### REMARKS

After entry of this Amendment, claims 1-21 are pending in this application. Claims 5, 7, and 16 are amended without introduction of new matter. Non-limiting support for the amended language is self-evident or evident from the discussion below.

Figure 4: Complete Block Diagram of BF-SDM.

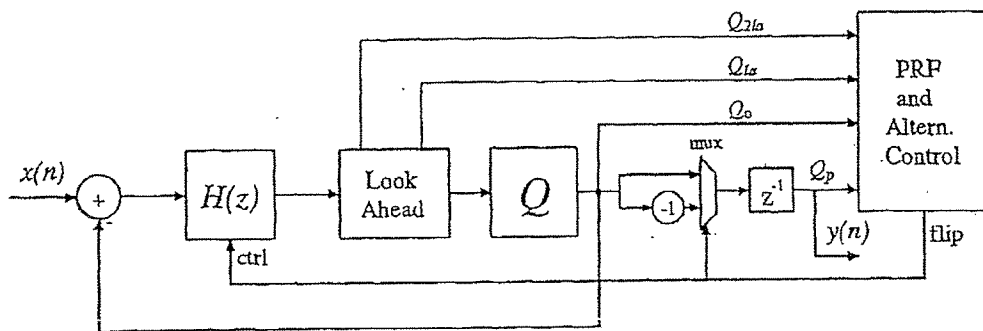
Claims 1 and 7 stand rejected under 35 U.S.C. 102(b) as being anticipated by Magrath et al., "Design and Implementation of a FPGA Sigma-Delta Power DAC" (hereinafter "Magrath"). Reconsideration is respectfully requested.

The outstanding Office Action cites Magrath's "integrator with mux in fig. 4" as teaching the recited integrator. Magrath's Figure 4 is shown below. As can be seen, the "integrator with mux in fig. 4" is arranged after the quantizer, and not "in the input signal path between the input and the quantiser", as claimed. Thus, as the cited reference does not teach each and every recited element as arranged, this rejection under 35 U.S.C. §102 is improper.

Accordingly, for at least the above-stated reasons, Applicant respectfully requests that this rejection be withdrawn.
